APPLICATION OF SOUTHERN MADISON)
WATER DISTRICT FOR CERTIFICATE OF)
CONVENIENCE AND NECESSITY TO COMPLETE) CASE NO. 92-161
CONSTRUCTION OF STORAGE FACILITIES)

O R D E R

INVESTIGATION OF THE HYDRAULIC CAPABILITY OF THE
SOUTHERN MADISON WATER DISTRICT
CASE NO. 92-161

January 29, 1993

Figure No. 1

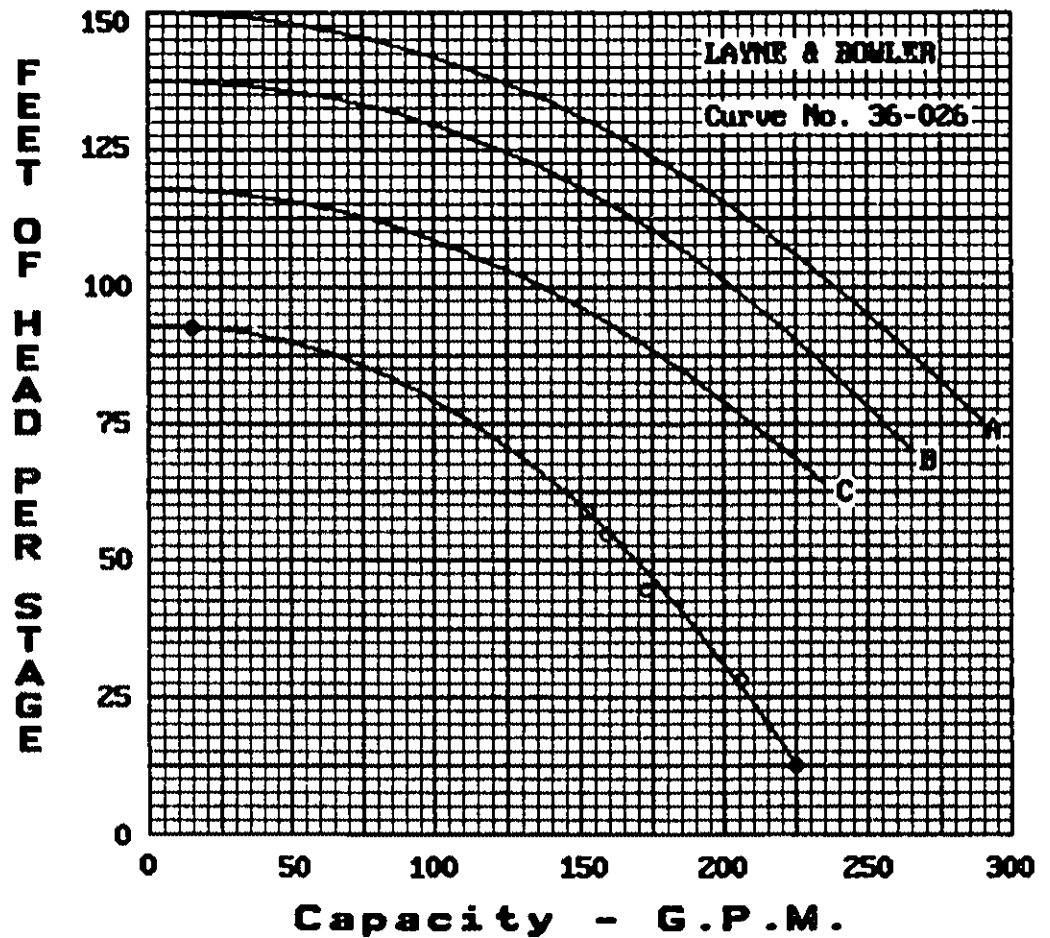
During the Commission's engineering staff's review of Southern Madison's construction proposal in Case No. 90-305 a copy of the manufacturer's pump curve was obtained from the pump station manufacturer (copy attached). The pump operation data contained in Table IV was reduced to pump flow VS head per stage for each of the

observed points and plotted on a pump capacity graph. A computer program was written to calculate and draw a pump characteristic curve to fit the plotted points using the pump formula used in Dr. Wood's KYPIPE program. The curve as constructed is subject to some error, of course, due to the limited range of operation points and the lack of precise measurements. Nevertheless, the curve is a useful indication of the capability of the District's I-75 pump station. In addition to the constructed curve the three characteristic curves "A", "B", and "C" from Layne & Bowler Curve No. 36-026 were also computer drawn on the head VS capacity graph for comparison. This graph is shown on following page as Figure No. 1.

The pump curve calculated from the field test data and shown in Figure No. 1 was substituted for the two pumps at Southern Madison's I-75 pump station. Pump No. 1 was entered as a two-stage pump and Pump No. 2 was entered as a three-stage pump. The constrained pipe feature of KYPIPE2 was utilized to calculate a minor loss component for the partially closed valve in the pump station by-pass pipeline. This feature was used to match the three different valve settings used on October 21, 1992.

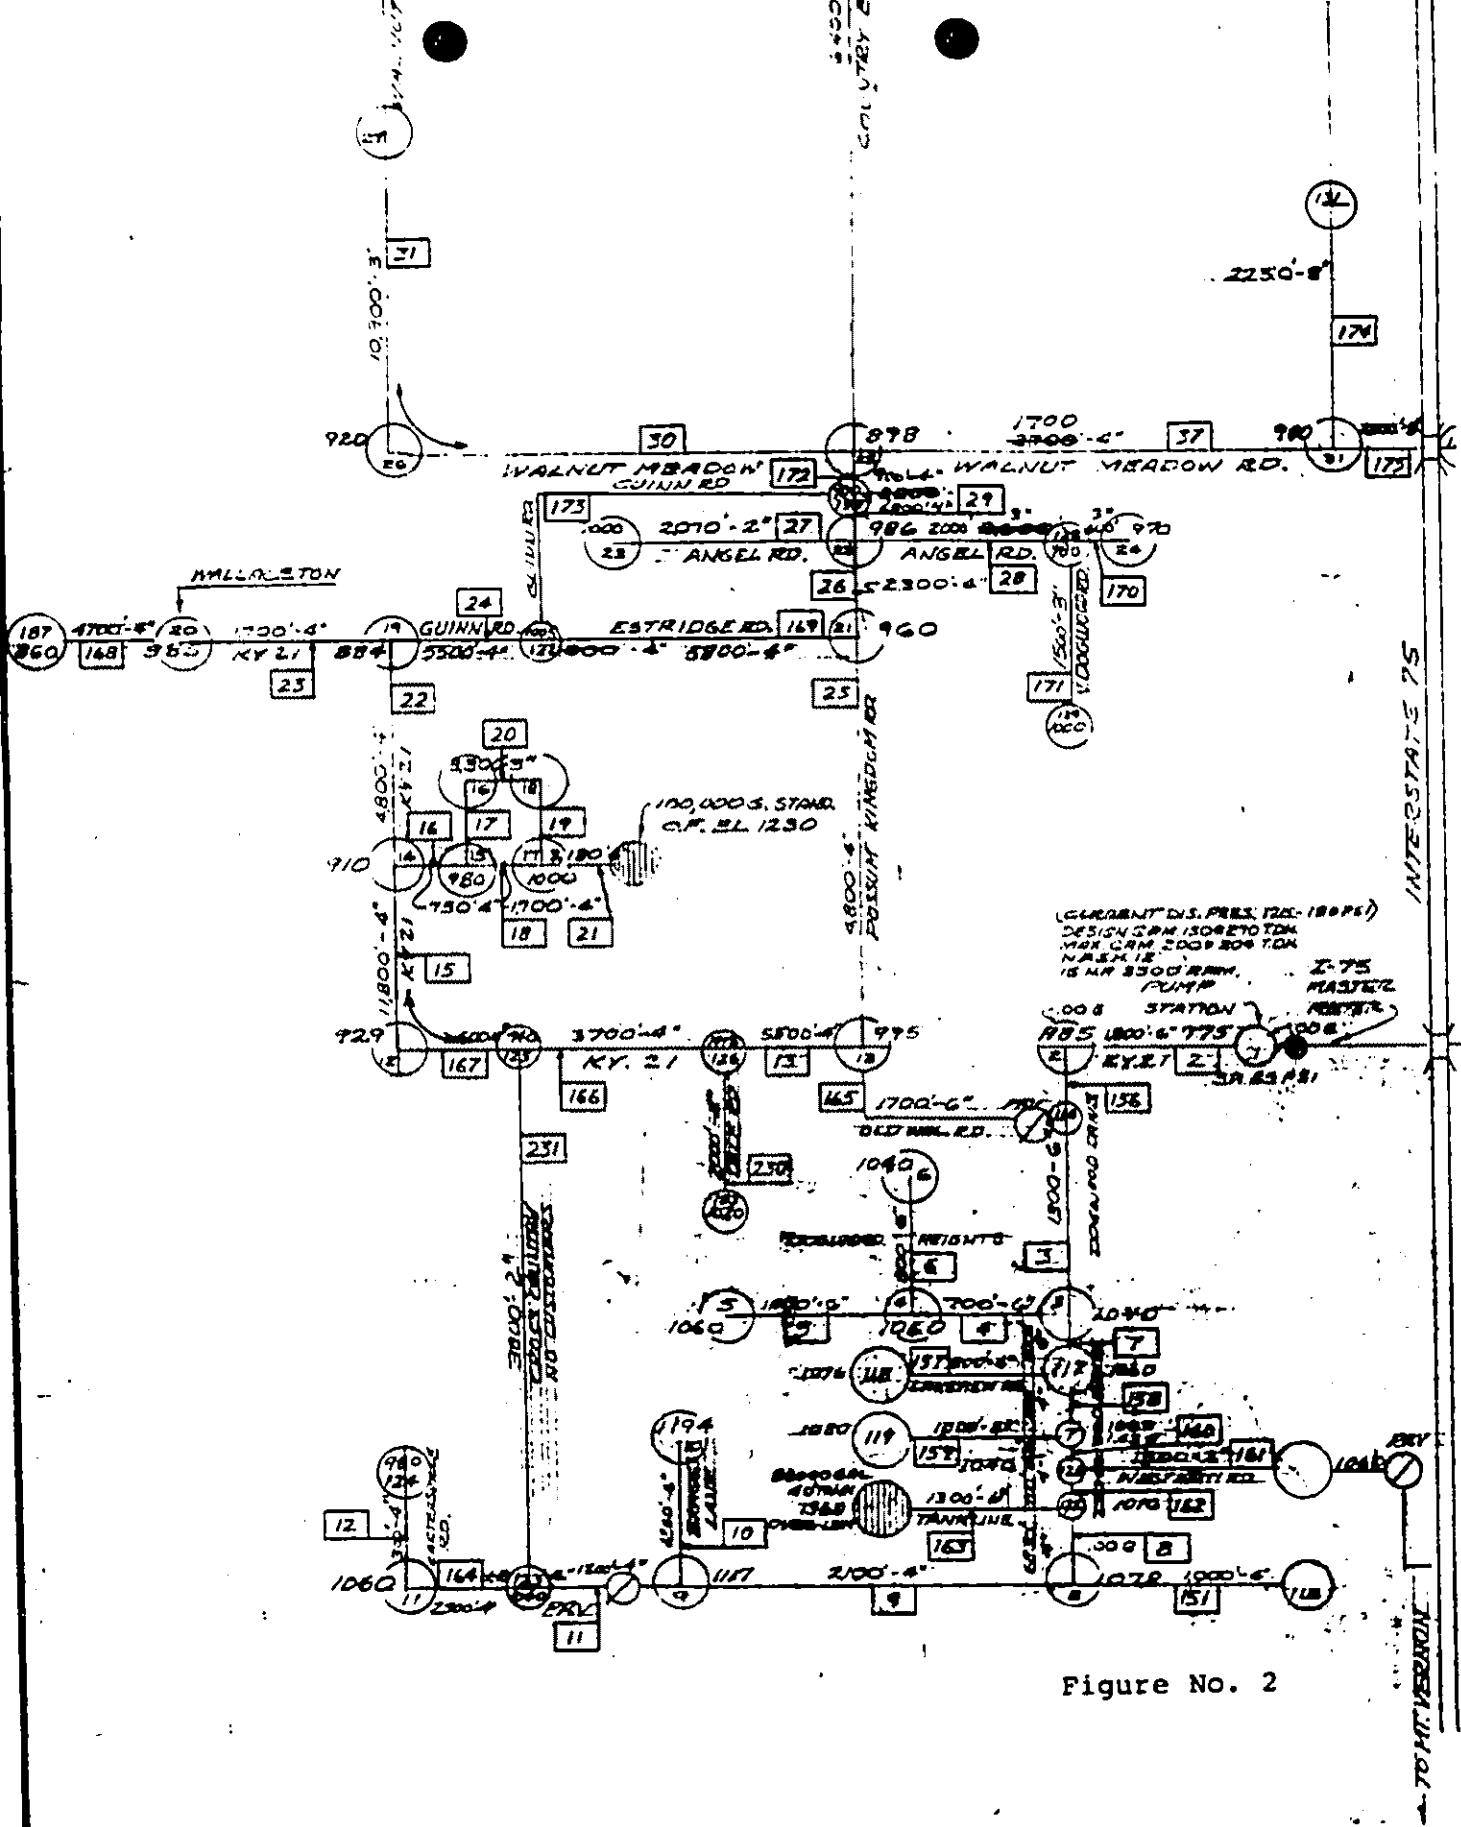
To evaluate Southern Madison's proposal to place the tank it constructed on Dogwood Drive in service it was first necessary to verify Southern Madison's computer model of the distribution system. Due to the size of Southern Madison's water distribution system and the limited amount of field data available to the Commission's engineering staff it was decided to truncate the hydraulic model to that portion of the system served by the I-75 pump station south of the EKP Substation on Walnut Meadow Road. The section of Southern Madison's schematic map showing this part of its distribution system is included as Figure No. 2. The time period selected for the calibration effort was the 24-hour period

The computer modeling effort itself consisted of inputting the water system data for analysis into the KYPIPE2 computer program developed by Dr. Don Wood at the University of Kentucky. Initial changes made to the system data as submitted by Southern Madison included closing the pipeline shown on the schematic layout as pipe 169 on Estridge Road, and closing the pipeline labeled as pipe 17 shown in the Indian Hills subdivision. The PRV's shown on the schematic on pipe 11 and pipe 161 do not exist and are not included in the model. In addition pipe 163 is 1,525 feet of 4-inch main instead of 1,300 feet of 6-inch shown on the schematic. These changes were based on discussions with Ray Curry about the system's layout and configuration. In addition the majority of the roughness coefficients for the pipeline were changed to a C-factor of 140 instead of the 145 C-factor used in Southern Madison's submittal. Southern Madison's September 11, 1992 response to the

Walnut Road. This type of pressure-regulating valve is not generally used on water distribution systems. After discussing this particular valve operation with Bill Gilbert at the University of Kentucky's Department of Civil Engineering, he suggested that the differential control valve could be modeled in KYPIPE2 as a pump with a flattened head curve equal to the pressure drop in negative feet of head. The PRV shown on Southern Madison's schematic at pipe 165 was therefore replaced in the model by a pump with a head of negative 57.7 feet.

Initial runs of the computer model immediately indicated that the pipeline along Possum Kingdom Road contained either a closed or partially closed valve somewhere along its length from Highway 21 to Walnut Meadow Road. Further review of the computations suggested that a partially opened valve was located somewhere in the vicinity of either Guynn or Possum Kingdom Roads. This situation was discussed with Ray Curry, manager of Southern Madison, and he commented that he had noticed restricted flow conditions during past maintenance on Possum Kingdom Road. It was decided to use KYPIPE2's constrained pipe feature to calculate a minor loss component for the section of pipeline labeled pipe 29 on Southern Madison's schematic.
